## PRODUCT CHANGE NOTIFICATION

**PCN:** PCN211204

**Subject:** Qualification of Daewon Tray at ChipMOS Test and Finish Site for 44-Lead TSOP II Package Memory Products

TITLE TRAY, 44 TSOPII (DAEWON)			
SIZE A	PART NO. TZ44-II-*	DWG NO 001-94661	REV **
SCALED TO FIT	ENG'G REV 00	SHEET 2 OF 2

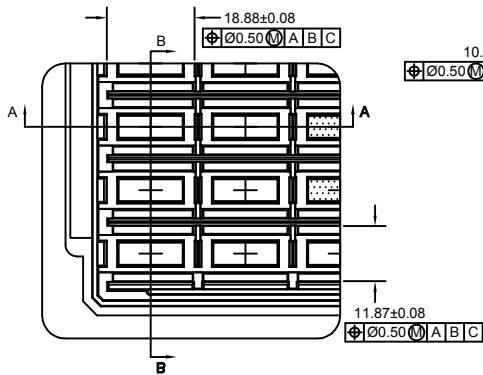
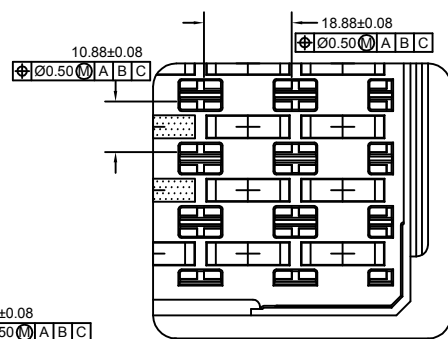
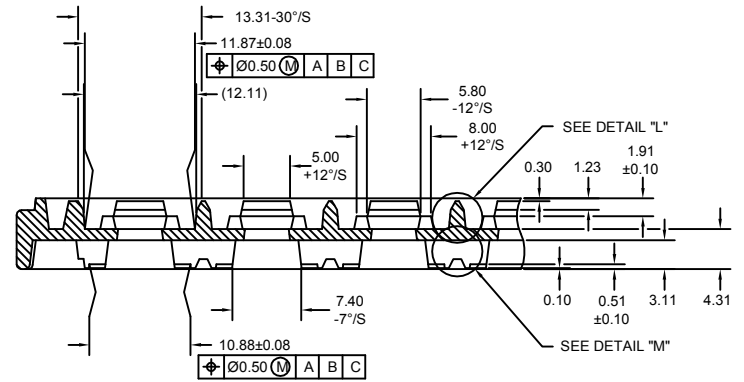
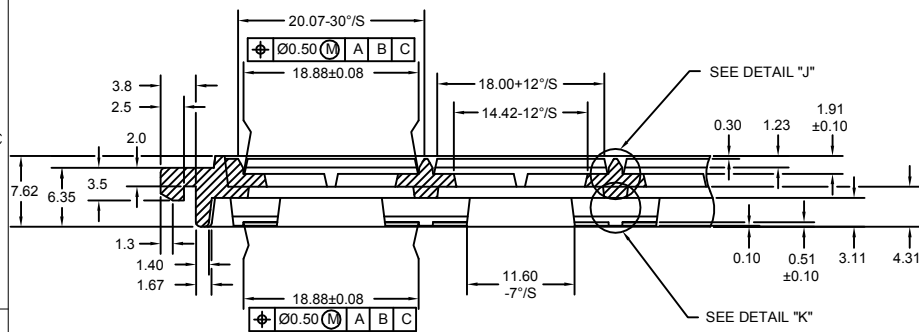
Cypress announces the qualification of Daewon tray to be used for 44-Lead TSOP II package tested and finish processed at ChipMOS Technologies Inc., Taiwan. This tray is qualified and currently in use by Cypress and its other Test and Finish subcons.

Items	Existing	New
Manufacturer	KOSTAT	DAEWON
Supplier Part Number	KS-8503	TR142050
Cypress Drawing Number	51-52029	001-94661
Tray Color	Black	Black
Temperature Rating	150°C	150°C
Number of Pockets / Units per Tray	135	135
Tray Length	315.0 ± 0.25 mm	315.0 ± 0.25 mm
Tray Width	135.9 ± 0.25 mm	135.9 ± 0.25 mm
Tray Stacking Height	6.35 ± 0.13 mm	6.35 ± 0.13 mm
1 <sup>st</sup> Pocket X-Position	14.56 ± 0.13 mm	14.56 ± 0.13 mm
1 <sup>st</sup> Pocket Y-Position	13.27 ± 0.13 mm	13.27 ± 0.13 mm
Pocket X-Pitch	20.42 ± 0.13 mm	20.42 ± 0.13 mm
Pocket Y-Pitch	13.67 ± 0.13 mm	13.67 ± 0.13 mm
Top Pocket Length	18.88 ± 0.25 mm	18.88 ± 0.08 mm
Top Pocket Width	11.96 ± 0.25 mm	11.87 ± 0.08 mm
Pocket Depth	1.91 ± 0.25 mm	1.91 ± 0.10 mm
